# **DSC Change Proposal**

Change Reference Number: XRN 4687

Change Title	PSR updates for large domestic sites		
Date Raised	01/06/2018		
Sponsor Organisation	E.ON		
Sponsor Name	Kirsty Dudley		
Sponsor Contact Details	Kirsty.Dudley@eonenergy.com		
Xoserve Contact Name	Ellie Rogers		
Xoserve Contact Details	Ellie.rogers@xoserve.com		
Change Status	Proposal / With DSG / Out for Consultation / Voting / Approved or		
	Rejected		
Section A1: Impacted Parties			
Customer Class(es)	⊠ Shipper		
	National Grid Transmission		
	☑ Distribution Network Operator		
	iGT		
Section A2: Proposer Requirements / Final (redlined) Change			
Suppliers and Transporters have lice This is maintained through a Priority Shipper) submitting this information t	nce obligations to record and share domestic customer vulnerability. Service Register (PSR). This is fulfilled through the Supplier (via the o the CDSP to be recorded and issued to the relevant GT. This the electricity DNO who holds the overall central PSR registry.

Please see attached the updated CFR hierarchy for review and approval:

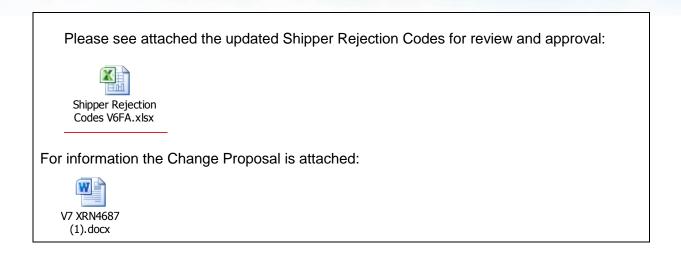
- Amendment to the CFR Confirmation Response hierarchy to reflect the changes made to the CNF hierarchy which allows Shippers to submit the PSR information at confirmation of an LSP.
- The proposed change adds S83 End Consumer Details and the S84 Priority Services records to the S09 Reject Confirmation and S66 Contact Details records as a level 3. The S72 Rejection Detail records have been added to both records as a level 4.
- The occurrence and optionality for the S83, S84 and S72 records reflects the ability to provide this information.
- The number of occurrences for the S66 record is also being increased to 6 to allow up to 5 Emergency (EMR) contacts and a Consumer (CON) contact to be provided in the Confirmation Response records S07, S09, S16 & S10.
